## Relevant Information for Local Planning Panel

**FILE:** D/2020/1453 **DATE:** 19 May 2021

**SUBJECT:** Information Relevant To Item 3 – Development Application: 43 Avona Avenue, Glebe – D/2020/1453

Figure 1: Excerpt of proposed level 2 floor plan, depicting applicant's requested modification to the eastern elevation balcony.

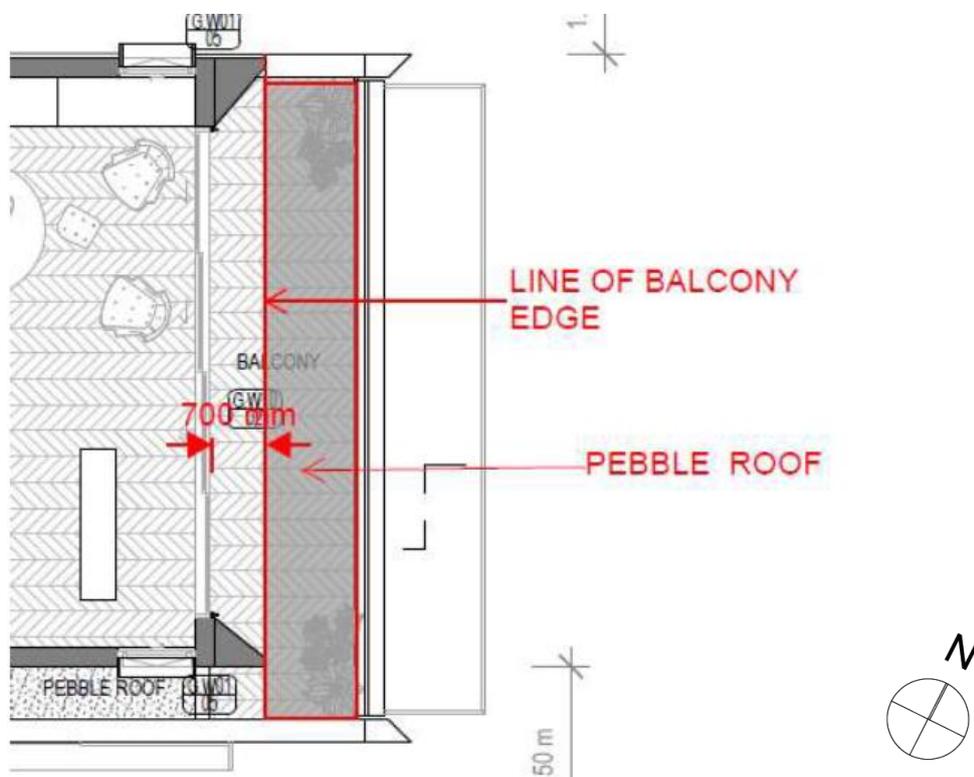
- The modification of the design to a 700mm deep balcony, which is recessed behind the existing blade walls would not present additional privacy impacts beyond that of a Juliette style balcony but will improve the amenity of the master bedroom. See Figure 1 below.

The suggested balcony design modification at Level 2 is not supported.

Section 4.1.8.1 of the Sydney DCP 2012 states that balconies and decks above ground floor are to be located and designed to minimise overlooking of surrounding buildings and be avoided at the rear and side of a dwelling.

The level 2 balcony is located at the rear of the dwelling and will sit above surrounding properties. Extending the balcony to the edge of the blade walls will still result in overlooking of 11-15 Cook Street and 41 Avona Avenue, creating adverse privacy impacts.

- (c) The eastern elevation balcony at Level 2 is to be deleted. Floor to ceiling height glazed windows may remain, with a balustrade installed flush to the glass line. Balcony projection is to be blocked off and replaced with roofing.

The proposed modification of the balustrades to the eastern elevation are supported in this instance as the level 1 balcony has been conditioned so that it no longer projects beyond the blade walls and will not be visible from Avona Avenue. The level 2 balcony is to remain a Juliette balcony in accordance with Condition 2(c), with the balustrade sitting flush against the floor to ceiling window.
